**Re: Progress Report No. 18, District on the River Redevelopment
December 2022**

Sagamore Spokane, LLC; PPCD No. 21200059-32
Facility/Site ID #1523145 and Cleanup Site ID #3509
Project No. 190210

Attachments: Foundation Plan Markups of Test Helical Piles S-101

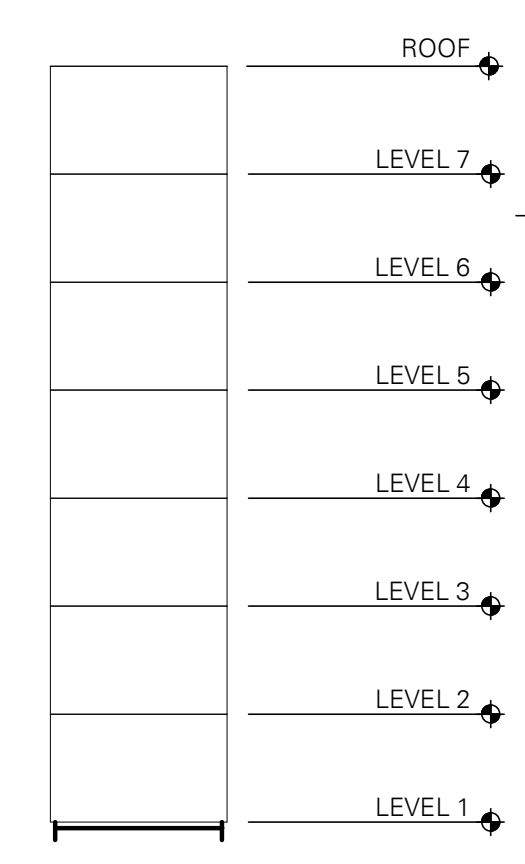
- Test grouted helical piles were installed within the Building 2A footprint. Test grouted helical piles Test HP-07, Test HP-09, and Test HP-10 were installed on December 05, 2023, to a minimum tip elevation of 1858 (25 feet bgs)¹ and have not yet been static load tested. See attached foundation plan mark-ups for Test Helical Pile locations. All test helical piles were dynamic load tested on December 7, 8, and 9, 2023.
